RE: TEDS Exception No. 06-03, to Reduce Access Spacing at 2976 Gunnison Avenue

## **DESIGN EXCEPTION #DE06-03**

RE: Request to Reduce Access Spacing at 2976 Gunnison

# **Request for TEDS Exception**

1. Reduction of the Site Plan

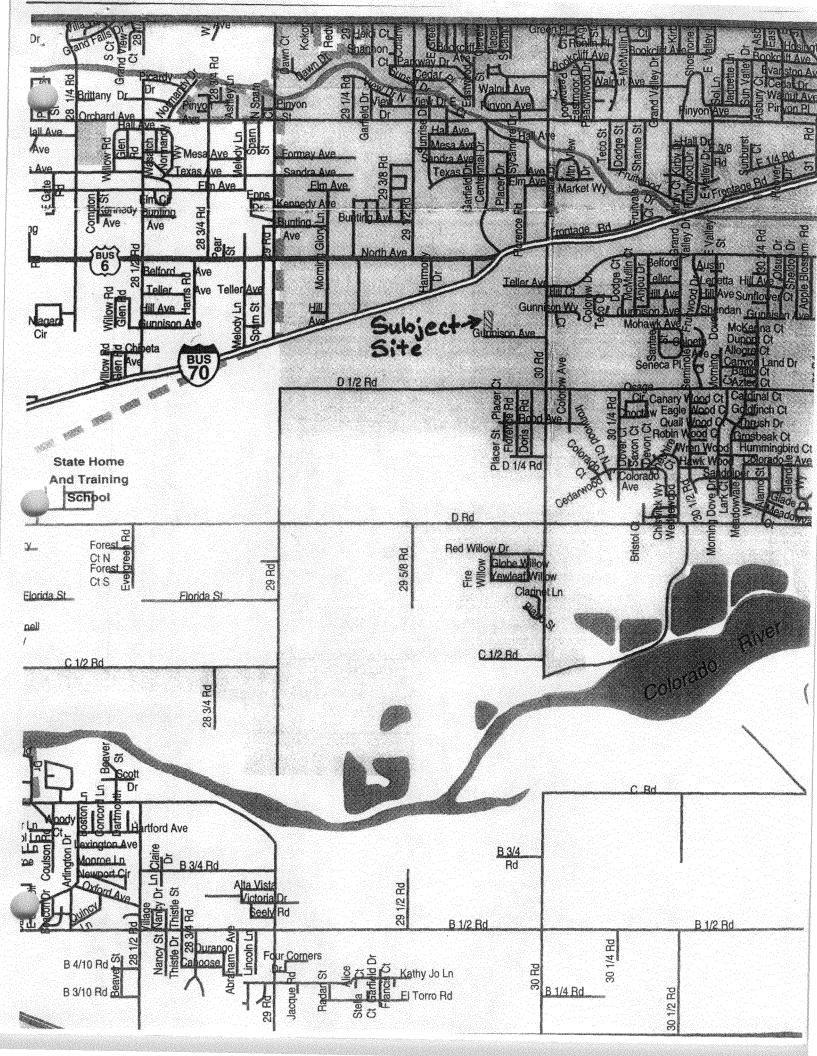
For reasons beyond the control of the applicant, access spacing of 150' feet is not practically possible. The access spacing in this case is dictated by the existing access drive of the adjacent property owner to the east. This access has been located very close to the subject site; it is approximately 16' from the near edge to the common property line. The subject site has approximately 151' of frontage on Gunnison Ave. In order to meet the spacing requirement of 150' the subject site's access would have to be placed within 16' of the west property line. This would also place the access within 11' of the end of pavement on Gunnison Ave. Gunnison Ave. is a dead end road and the site is the last lot at the end of the road. The existing drainage facilities for Gunnison Ave. and Banner Industrial Park Subdivision are located in this area. There are existing inlets located 17' from the end of pavement on Gunnison Ave. The subject site is further encumbered on the west side by an existing 30' drainage easement as well as proposed drainage structures and swales necessary to accommodate onsite and offsite storm/irrigation water.

The applicant proposes to locate the access more centrally within the subject site. This would create an access spacing of 108' from centerline to centerline to the existing access to the east. There are no existing accesses to the west. This design would have no expected detrimental effects on traffic flow in Gunnison Ave. There would be no expected turning conflicts due to the small volume of traffic at the end of Gunnison Ave. and because there is no east bound traffic from beyond the subject site. The TEDS manual requires that accesses on opposite sides of a roadway be directly across from one another when possible. There is no existing access for the lot opposite from the site on Gunnison Ave., however when this lot is developed it would likely have the same concerns as the subject site listed above and therefore have its access located centrally on the lot as well.

Locating the proposed access to satisfy the TEDS requirement of 150' access spacing would require the unnecessary removal and relocation of the existing storm sewer system for Gunnison Ave. as well as the addition of a curve or turn to the east within the site which would complicate access and decrease turning vehicle storage.

I recommend approval of the requested Design Exceptions to Section 4.1.1 to allow the new parking lot access from Gunnison Avenue as long as it is designed to meet all other requirements of the TEDS.
